Hathaway Park

Town of Freetown ADA Transition Plan

May 2023

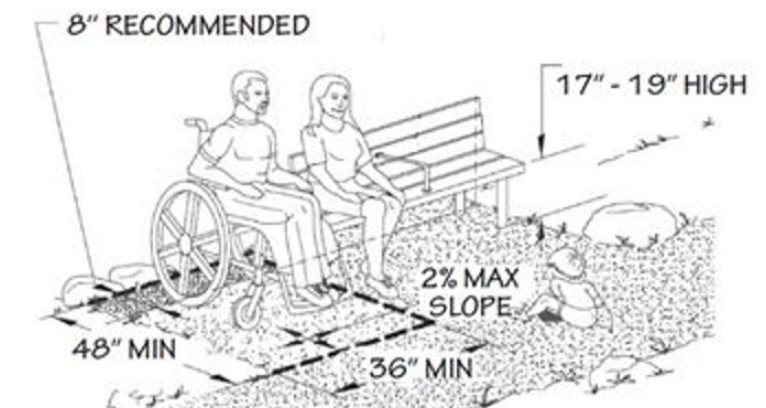
- Recommend providing a 36" by 48" firm, stable and slip-resistant area alongside one bench in each area where benches are provided so that a person using a wheelchair or other mobility device is able to sit alongside someone seated on the bench with their shoulders aligned. See the following illustration for best practice recommendations for benches:

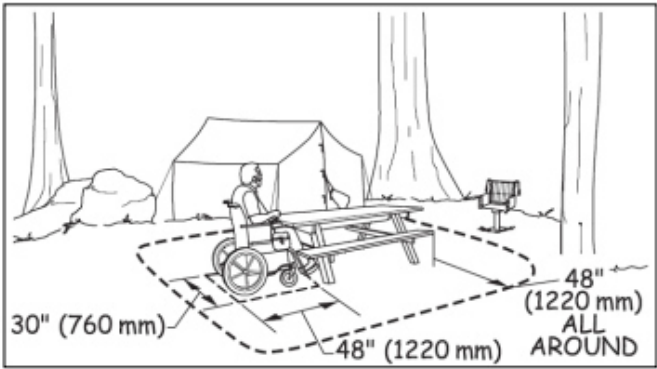
- Recommend providing a stable, firm and slip-resistant surface that is 48" clear on all sides of the accessible picnic table. See the following illustration:
